# Groundwater Application Review Summary Form

Application # G- 19051

**WATER RESOURCES DEPARTMENT****MEMO**6/29/2023**TO: Application G- 19051****FROM: GW: Joe Kemper**  
(Reviewer's Name)**SUBJECT: Scenic Waterway Interference & General/Local Surface Water Evaluation for Deschutes Ground Water Study Area**

TO: Water Rights Section Date 6/29/2023
FROM: Groundwater Section Joe Kemper Reviewer's Name
SUBJECT: Application G- 19051 Supersedes review of 11/18/2021 Date of Review(s)

D1. Well #: 1 Logid: DESC 62485

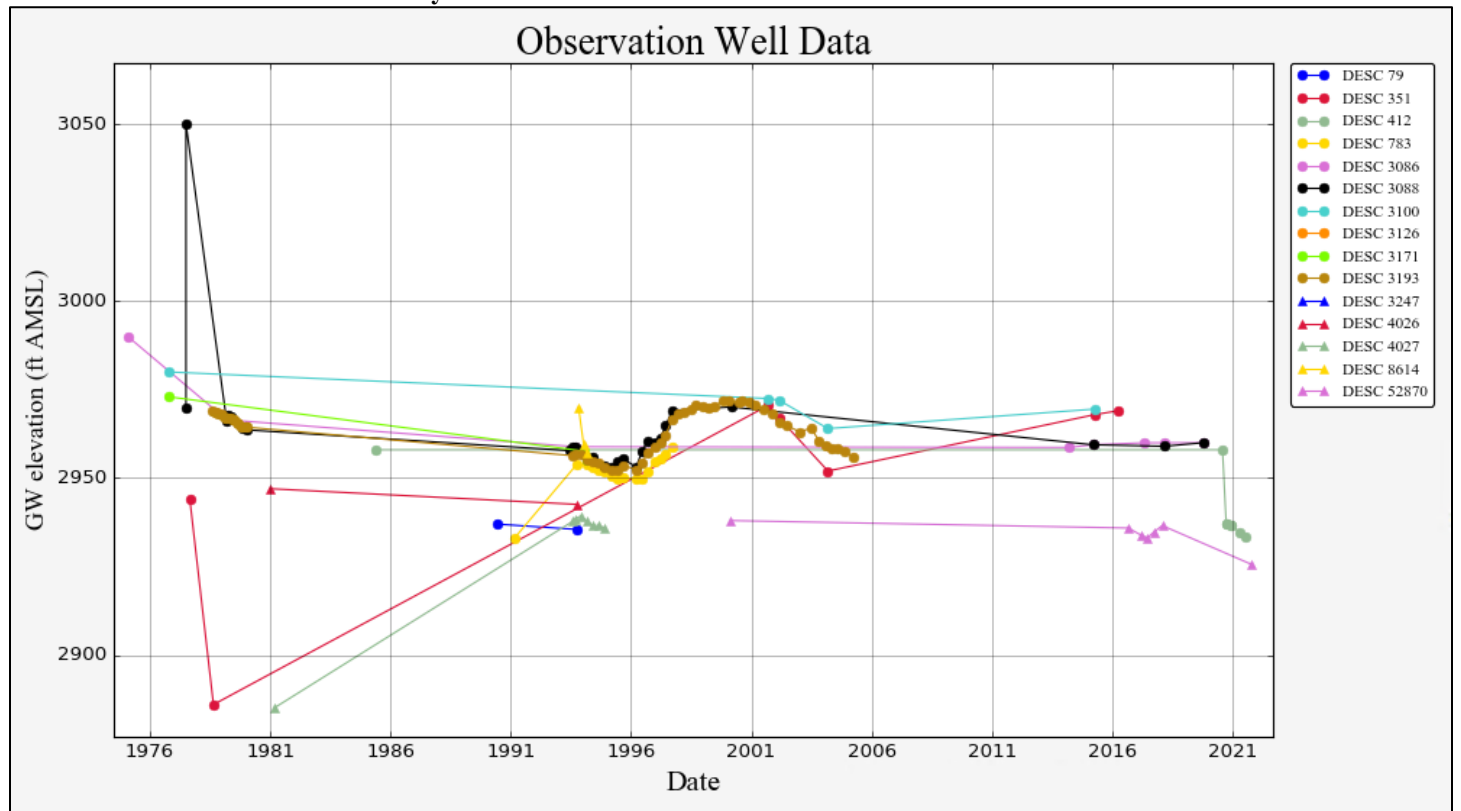
D2. **THE WELL does not appear to meet current well construction standards based upon:**

- a.  review of the well log;
- b.  field inspection by \_\_\_\_\_;
- c.  report of CWRE \_\_\_\_\_;
- d.  other: (specify) DESC 62485 was drilled in the approximate location of the proposed POA and is likely the proposed source for this application and should be reviewed as such.

D4.  **Route to the Well Construction and Compliance Section for a review of existing well construction.**
